Department of Energy
Carlsbad Area Office
P. O. Box 3090
Carlsbad, New Mexico 88221

This purpose of this letter is to request approval from the Environmental Protection Agency for the elimination of the magnesium oxide (MgO) mini-sacks from the Waste Isolation Pilot Plant (WIPP) repository. We previously briefed your agency regarding this subject on April 13, 2000, in Washington, D. C.

MgO Mini-Sack Elimination Submittal

Figure 1: Current Backfill System Arrangement

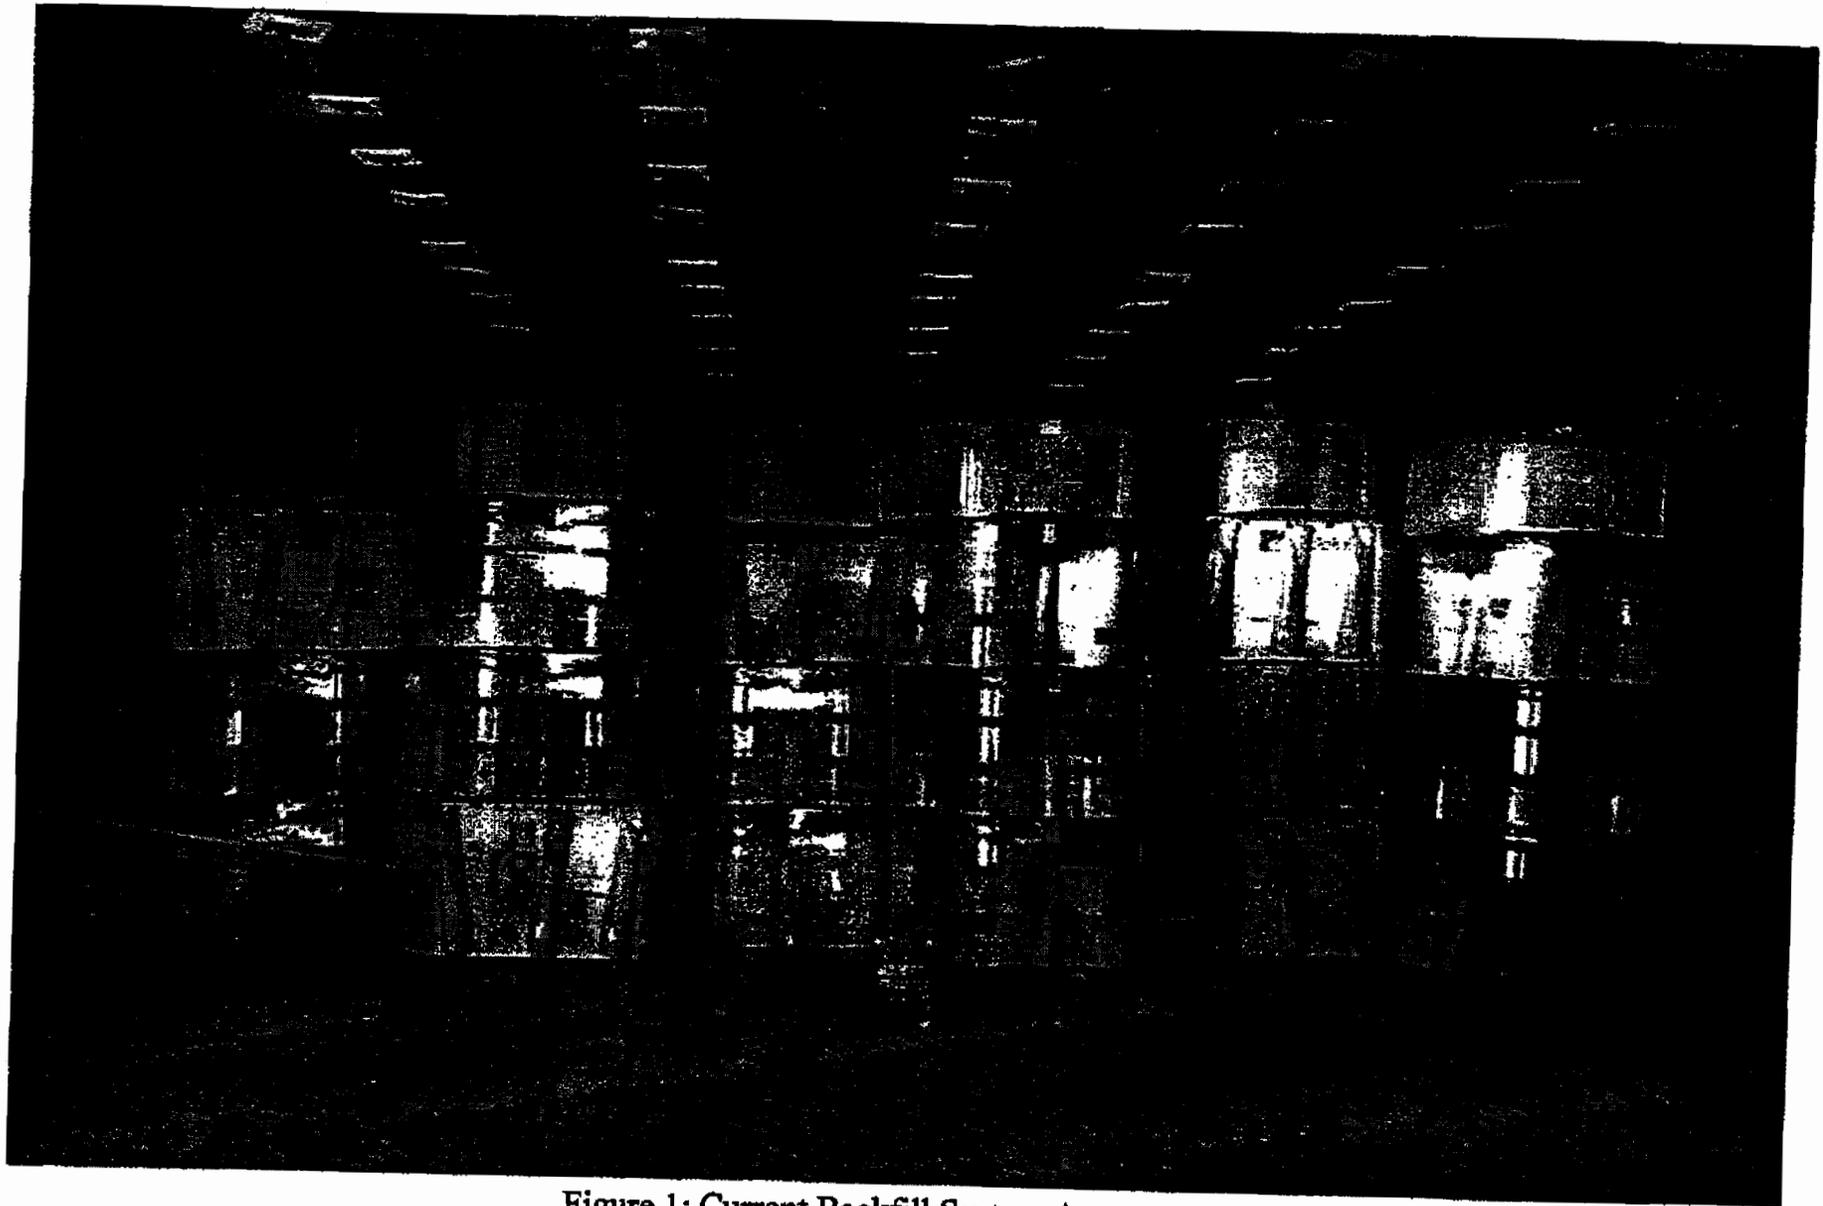
repository. The compliance baseline[1] for the backfill system in WIPP disposal areas calls for 85,600 tons (1.93×10^9 moles) of MgO, arranged as depicted in Figure 1. Approximately 15% of this total is emplaced as mini-sacks between and around waste containers. As experience is gained from the actual operation of a facility, changes to procedures, processes, and system designs which may enhance safety and improve operational efficiency are often recognized. DOE recently conducted a review of WIPP's disposal operations and determined that changes to the emplacement strategy for MgO could significantly enhance worker safety for the WIPP program, while continuing to meet all of the functional requirements associated with MgO. This document describes the removal of mini-sacks from the MgO emplacement strategy and discusses why this removal will have no impact on long-term WIPP performance.

In this submittal, DOE proposes elimination of the mini-sacks between the waste drums and stacked along the ribs. This constitutes removal of approximately 15% of the total mass of MgO from the repository, but retains 74,000 tons, or an equivalent of 1.65×10^9 moles of MgO in the waste disposal areas..
